# UNITED STATES PATENT AND TRADEMARK OFFICE

APPLICATION NO.	FILING DATE	FIRST NAMED INVENTOR	ATTORNEY DOCKET NO.	CONFIRMATION NO.
10/018,596	03/14/2002	Gerhard Rinninger	15028	8380

**Office Action Summary**

## DETAILED ACTION

FIG. 1

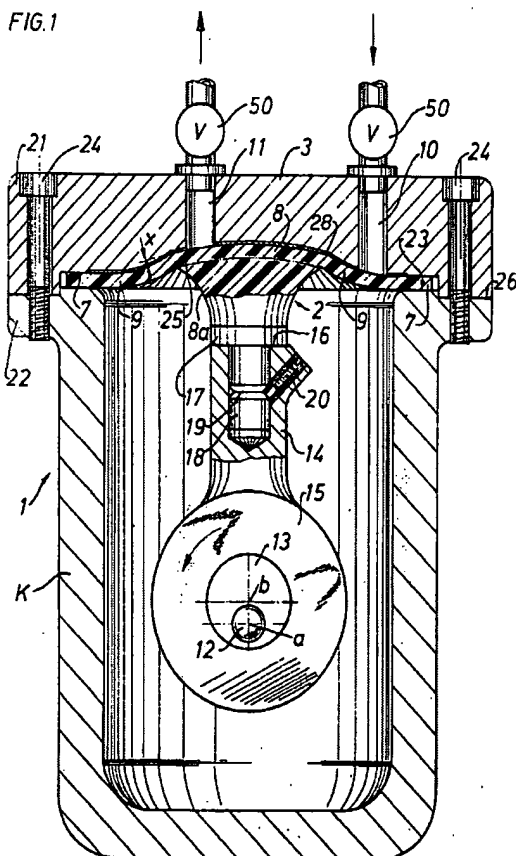
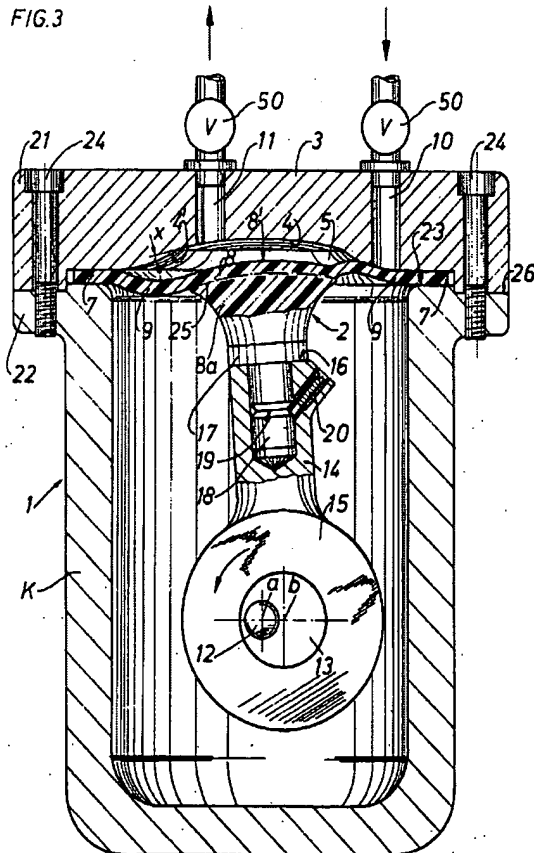
7. With respect to claim 10, **Becker** teaches a pump having a membrane 2 actuated by a crank drive, said membrane 2 bounds together with a concave pump body surface 4, a pump chamber 5, an inlet channel 10 and an outlet channel 11 which open out at an inlet opening and an outlet opening in the pump body surface 4, the membrane 2 having a membrane core 8a and an elastically deformable membrane ring 8 and the membrane core 8a having a convex surface adapted to the pump body surface 4, whereby the inlet opening is arranged in a region of the pump body surface 4 which the membrane 2 first approaches upon an expulsion stroke of the crank drive and the elastically deformable membrane ring 8 closes the inlet opening before the attainment of top dead center of the crank drive, wherein an inlet valve 50 is provided which is arranged in the region of the inlet opening of the inlet channel 10. See particularly **Figures 1, 3.**

8. With respect to claim 12, **Becker** teaches that the inlet opening has a surrounding edge (area surrounding the inlet opening) against which the elastically deformable membrane closes the inlet valve. See particularly **Figures 1, 3.**

9. With respect to claim 13, **Becker** teaches that the middle point of the inlet opening I lies at least approximately in the plane of rotation of the crank of the crank drive. See particularly **Figures 1, 3.**

10. With respect to claim 14, **Becker** teaches that the elastically deformable membrane ring 8 closes the inlet opening at a crank rotary position of the crank drive which is up to 90 degrees before top dead center. Notice that **Figure 1** is the TDC position while **Figure 3** is 90 degrees before TDC. To see this, refer to the location of the axes **a** and **b** corresponding to elements 12 and 13 respectively. As you can see from **Figure 3**, axis **a** and **b** are 90 degrees before TDC. See particularly **Figures 1, 3** and compare the location of elements **a** and **b**.

11. With respect to claim 15, **Becker** teaches that the elastically deformable membrane ring 8 closes the inlet opening at a crank rotary position of the crank drive which is 20 degrees to 90 degrees before top dead center. See particularly **Figures 1, 3** and compare the location of elements a and b.

12. With respect to claim 16, **Becker** teaches that the middle axis of the inlet channel 10 is orientated perpendicularly to the pump body surface 4. See particularly **Figures 1, 3**.

13. With respect to claim 17, **Becker** teaches that the outlet opening of the outlet channel 11 is arranged in a region of the pump body surface 4 which the membrane 2 approaches last and which is attained by the membrane 2 at the earliest at top dead center of the crank drive. See particularly **Figures 1, 3**.

14. With respect to claim 18, **Becker** teaches that the middle point of the outlet opening of the outlet channel 11 is arranged in an inner region of the pump body surface 4 which lies opposite to the membrane core 8a of the membrane 2. See particularly **Figures 1, 3**.
